DP/ID/SER.A/822
20 March 1987
ENGLISH

INVESTIGATION OF CONCRETE STRUCTURES
IN THE AMRAN CEMENT PLANT

SI/YEM/86/801

Technical report: Strength assessment of the structure *

FIG. 1 GOOD BASE DET. NO SECOND STAGE CONC.

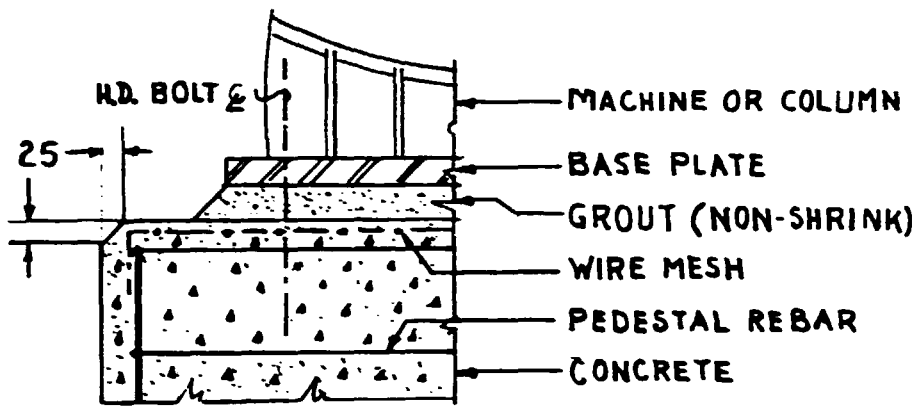
have been excellent. One staircase detail in housing drawing No. 5-07 is not as per standard detail. The lower bar at the stair-slab junction can come out. This kind of error is not repeated elsewhere. Diagonal bars could justifiably be absent in tunnels but should be present in retaining walls. If the site is expected to follow standard drawings for these bars in particular, it is not noted so, and perhaps such diagonal bars are not placed. The standard drawing shows the junction of roof beam and the block wall with a dowel from the wall into the beam. This is fine for a concrete framed building. In the case of load-bearing walls in housing areas, this would be very undesirable. In fact in that case, there should be a paper joint for the slab to slide freely to shrink. This would have been ideal and would have prevented the widespread cracking of the block walls that now exist. Even the nominal reinforcement would have helped to some extent. Reinforcement has been detailed and then has been crossed out. This was an unfortunate decision. Details of second-stage concrete around column and machine base plates should have been shown on structural drawings. In fact, the second stage concrete or mortar finish from pedestal level to the top of the base plate level is undesirable. Such concrete is cracking at all places. Around machine plates, often 100 to 300 thick second stage concrete exists. This should have reinforcement to bond with pedestal bars and a horizontal wire mesh at the top. Also, such concrete should be separated from the base plate by a flexible strip. In that case, thermal or mechanical movement of the base plate would not crack the second stage concrete. See Figs. 1 and 2.

The cracks in the second stage concrete around the base plates are not of structural consequence in general. It is advisable to remove such concrete and alter the detail as per Fig. 1 so that the grout condition under the base plates can be always examined. If the grout thickness is more or for other reasons the second stage concrete must be level with the top of the base plates, detail of Fig. 2 shall be followed. Where the original detail is very sound, as for example in the powerhouse, it can remain. The cracks in the second stage concrete are caused by poor bond with the pedestal, thermal loads, vibrations or some combinations of these. This treatment is absolutely essential for the new look to the plant and for the durability. No client can be happy with the present state of affairs.

Remove unwanted second stage concrete from around the base plates of columns or machines that vibrate and from around those that do not vibrate but still show signs of cracking and spalling. They look sick. Grout under the base plates where grout has shrunk. Grout must fill the underside of the plates completely if distress to structures below is to be avoided. A shrunk grout causes stress concentrations. Adopt the detail of Fig. 1 or Fig. 2. The present detail is bad because it prevents the grout condition under base plates from being inspected, can lead water under base plates or in any case it cracks and spalls.

FIG. 3 SEPARATION JOINT AT TOP OF BLOCK WALL

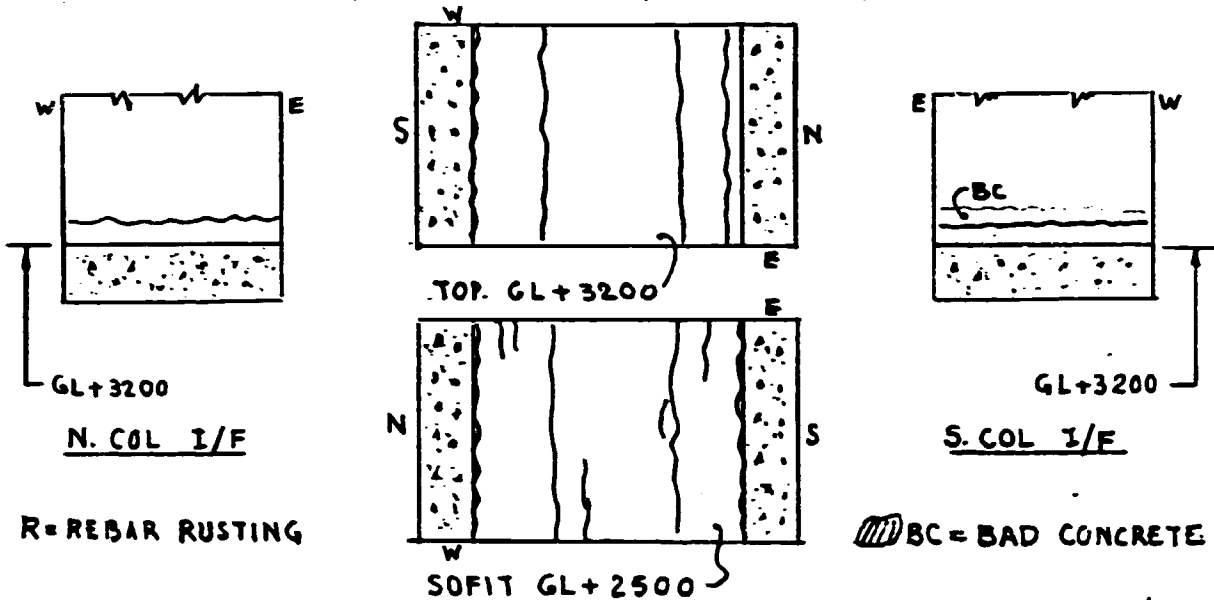
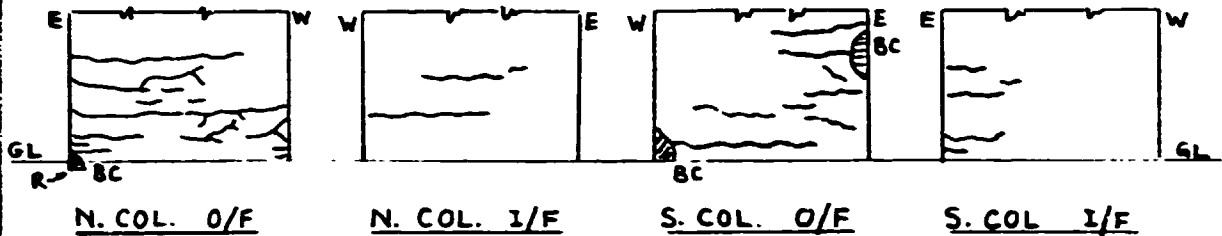
Thus, in case of housing there is no doubt it is the detailing error that has led to severe cracking. A nominal vertical and horizontal reinforcement would have helped a great deal in the reduction of cracks. Reinforcement is detailed on the drawing but has been crossed out. This economy too has contributed to ugly cracking. Seismic performance of unreinforced block wall is always questionable -- more so in cracked masonry, even after the repair.

FIG. 4 CRACKS KILN SUPPORT NO.2

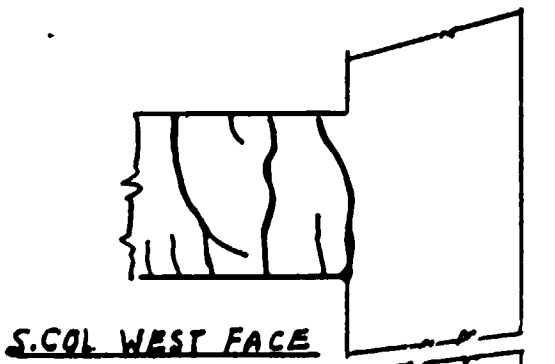
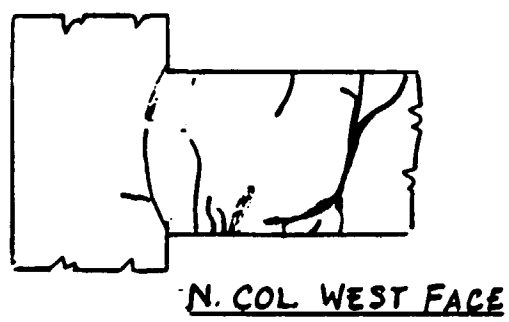
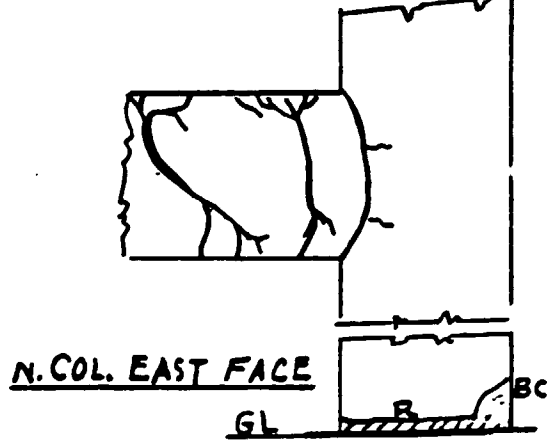
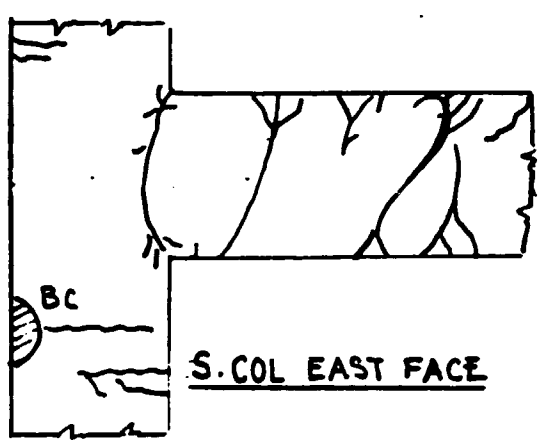
This report summarises the cracking problem then noticed and gives reasons for each distress. Causes noted are, shock load for LS hopper and Gypsum and Sandy Clay Hoppers, vibrations for girders and shrinkage or shrinkage and temperature for the remaining ten items. The report also suggests a full study by IHI and present guidelines as to how to go about it. They do not approve of the method adopted by IHI for rectification of LS hopper cracking. Consultant's opinion on cracks may be correct at that time. Now the damage to No. 2 kiln support is alarming.

cracks in No. 2 support are many and active. They are not shrinkage cracks. They are structural stress cracks. Support is very weak and must be repaired and modified. See Fig. 5. Bad concrete areas must be made good.
